Title: Hwy 47:06, South Robb Intersection, Km. 6.94, Intersection Sight Distance

Design Exception Request Date: June 5, 2013

Approval Status: Approved

Hwy 47 and Robb Access (NB)

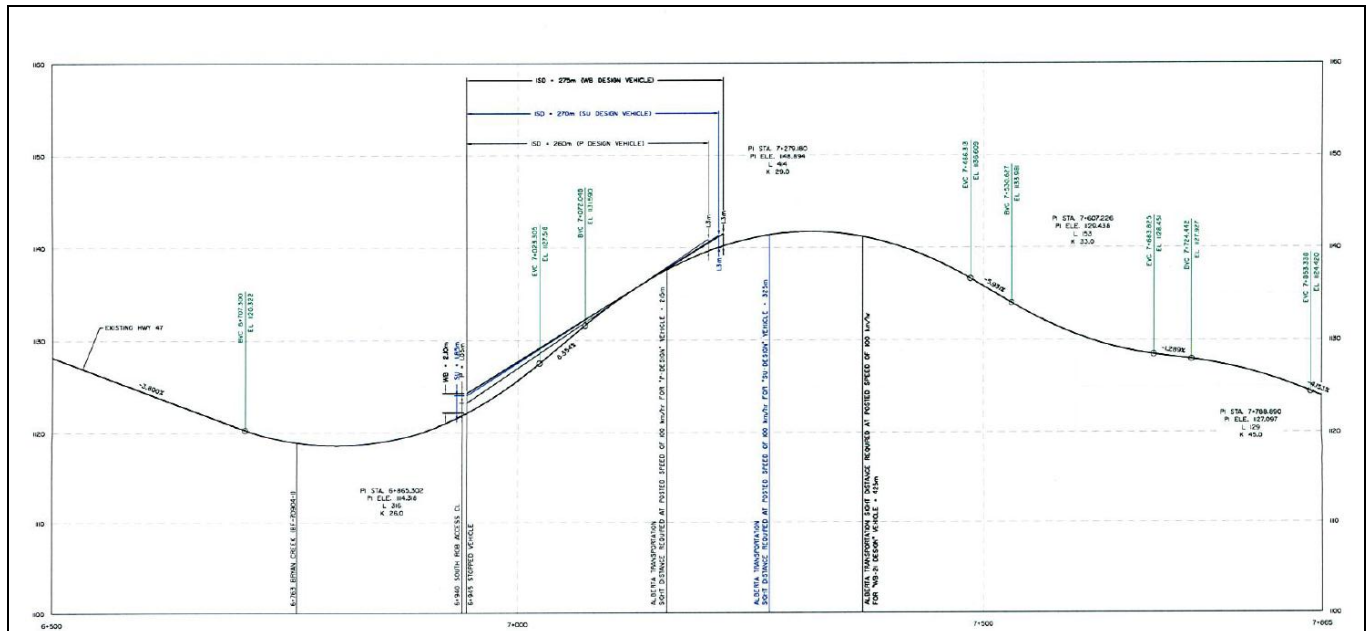
Summary
Current intersection sight distance (ISD) and stopping sight distance (SDD) are not adequate for a design speed of 110km/h. However, reconstruction of the road profile to meet a 110km/h design speed would be difficult due to existing site constraints. Thus, it is recommended to maintain the road profile and its 100km/h posted speed.

Rationale for Approval/Rejection
<ul style="list-style-type: none"> • Due to the topography and site constraints in the area, the consultant estimated that improving the ISD and SDD would cost 5 million dollars. Thus, improving the vertical alignment is not considered as cost effective. • The collision history from 2006 to 2010 for this intersection is considered good. There were 9 reported collisions. Within that, 2 were non-animal collisions, and both were PDO. • The existing Type 3a intersection treatment exceeds the warranted Type 1a intersection treatment.

Additional Mitigation Required
Concealed intersection sign (WA-13) will be installed in advance of the intersection along Highway 47.
